# Comments on SWRCB Draft Order Regarding NPDES Permit for the Sacramento Regional Wastewater Treatment Plant

July 18, 2012

# Mixing Zone Detail

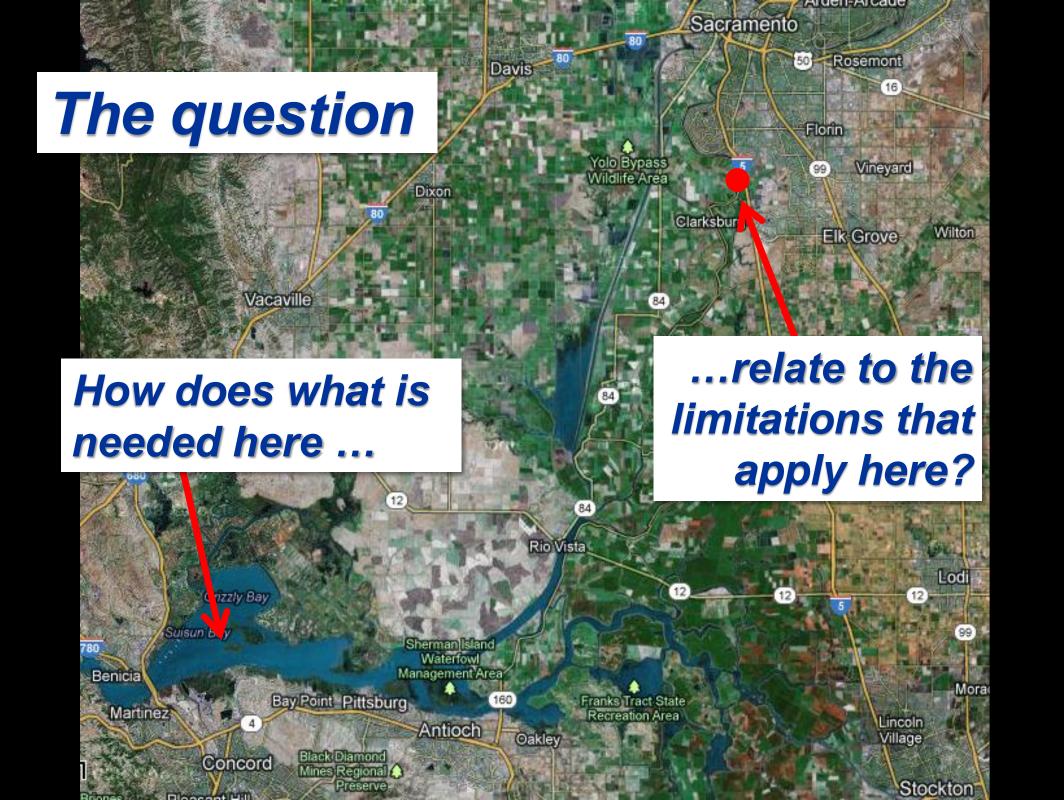
#### **Narrative Toxicity Objective Applies**

Current effluent ammonia = 33 mg/L monthly average

EPA ammonia criteria: 1.8 mg/L monthly ave.

EPA criteria met outside requested mixing zone with current effluent
